**RESOLUTION OF THE TOWN COUNCIL OF THE TOWN OF LOS GATOS
ADOPTING FINDINGS REQUIRED BY GOVERNMENT CODE § 65589.5(f)(6)(D)(iv)
IN RESPONSE TO NOTICE OF CHALLENGED CONDUCT
SUBMITTED TO THE TOWN ON OCTOBER 2, 2025**

**PROPERTY LOCATION: 14288 CAPRI DRIVE
APN: 406-30-016
ARCHITECTURE AND SITE APPLICATION: S-24-044
PROPERTY OWNER: LOS GATOS LLC
APPLICANT: SOCAL INDUSTRIAL EQUITIES**

**STAFF TECHNICAL REVIEW
PLANNING DIVISION
September 17, 2025**

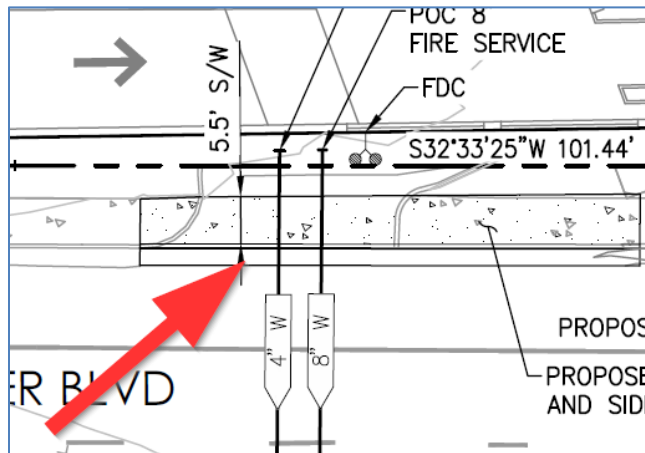
box trees or (54) 36" box trees. As proposed, only (23) 36" box trees are proposed, which would be short of the requirement by (31) 36" box trees or (62) 24" box trees. This would require an in-lieu payment of \$15,500 per Town Code. However, several of these trees may be exempt from the replacement requirement if they are determined to be "fruit-bearing" (Trees 10, 17, 20, 21, 26, 27, 30-36, and 39). This could drastically reduce the in-lieu fee.

New Sheet DG0.2:

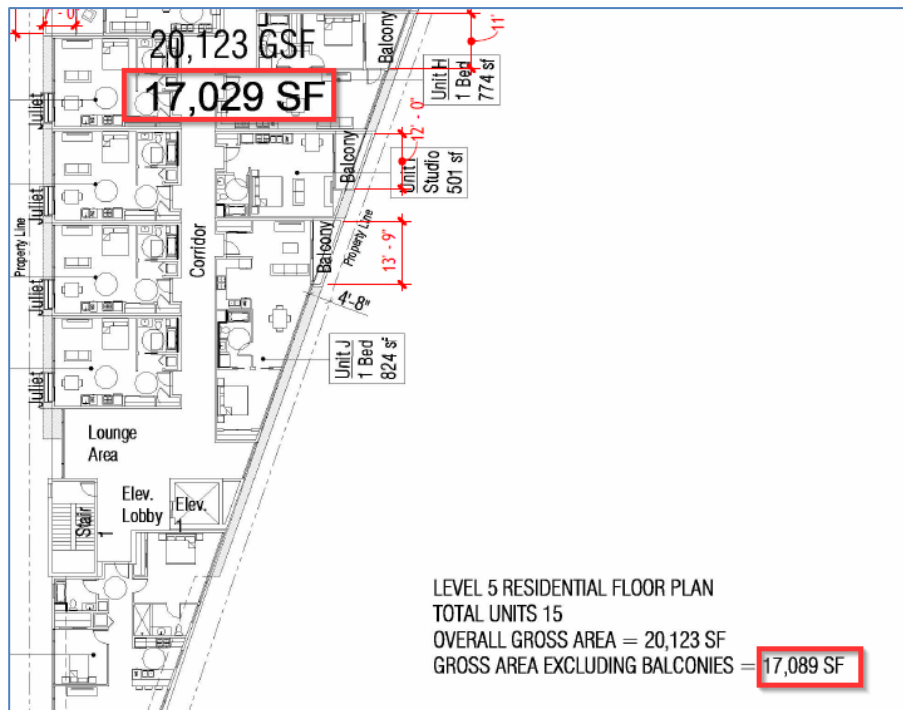
- 91) ~~Floor plan note 1 says there are 120 long-term bike parking spaces, when there are 166.~~
- 92) ~~Floor plan note 2 says to see detail DG0.1/3 for long-term bike parking details. Detail DG0.1/3 is a short-term space.~~
- 93) Plans were updated and now the long term bike parking notes are inconsistent. Ensure that in each table below, the floor plan matches the actual floor plan. For example, Level 3 floor

- plan table shows 52 long term bike spaces, while the call-out notes show 32 and 24 (56 total), and the call-out for 24 bike spaces is pointing to bike room 3, which shows 20 bikes. Similarly, Floor Plan Note 1 needs to be updated as the updated count is no longer 140, and bike parking is proposed on the first floor and not just levels 2-4. See below screenshot.
- 94) A new “continuous wheel stop see note 2” call-out was added, but note 2 does not correspond to wheel stops. Update accordingly.
- 95) A new “sunshade device outline” call-out was added, but the dimension is not noted. Specify how far it overhangs beyond the wall.
- 96) The dimensions for the southernmost architectural awning (above the lounge) are not accurate. The dimensions measure to the property line, and this awning does not extend that far.

Sheet A2.1:

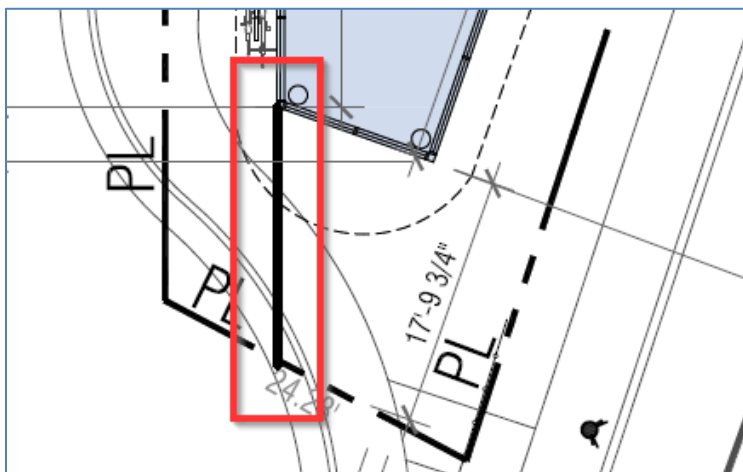
- 128) The revised cul-de-sac radius note (32') does not match the rest of the plans.
- 129) The sheet says "(E) cul-de-sac." There is no existing cul-de-sac at the site.
